PEUGEOT/CITROËN THERMOSTAT REDESIGN TO OVERCOME OVERHEATING ISSUES

Issue Date: 23/09/19 Issue Number: COTB0025F

APPLICATION: Citroën Berlingo, C3, C4, DS3, 207, 308, 3008, 5008, Partner

APPLICABLE REFERENCES: FTK102 / FTK481

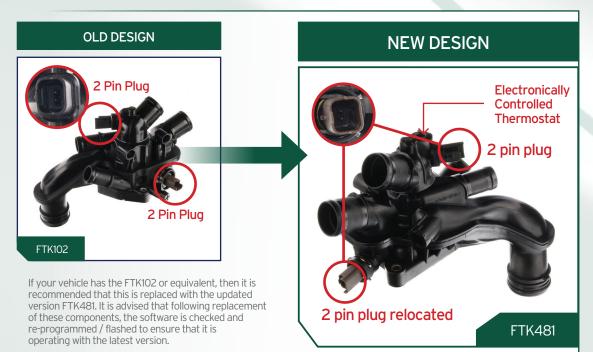
Due to an increase in overheating issues & symptoms such as an erratic temperature gauge, erratic running, radiator fan run-on, or poor heater function in the above vehicles, the O.E.M. have modified the design of the Thermostat housing. Following the O.E. specification, we have replaced the old design FTK102 with the new latest design FTK481. The latest design benefits from an electronically controlled thermostat, a reinforced structure, and a new configuration of sensors.

We have highlighted the key differences below so that you are clear that the latest part; although visually different to what may be on the vehicle, is in fact the correct product.

The modified version has had the lower 2 Pin connector relocated, therefore, a new cable may also be required to carry out the modification.

New Cable: FTS3091 - Thermostat Wiring Harness
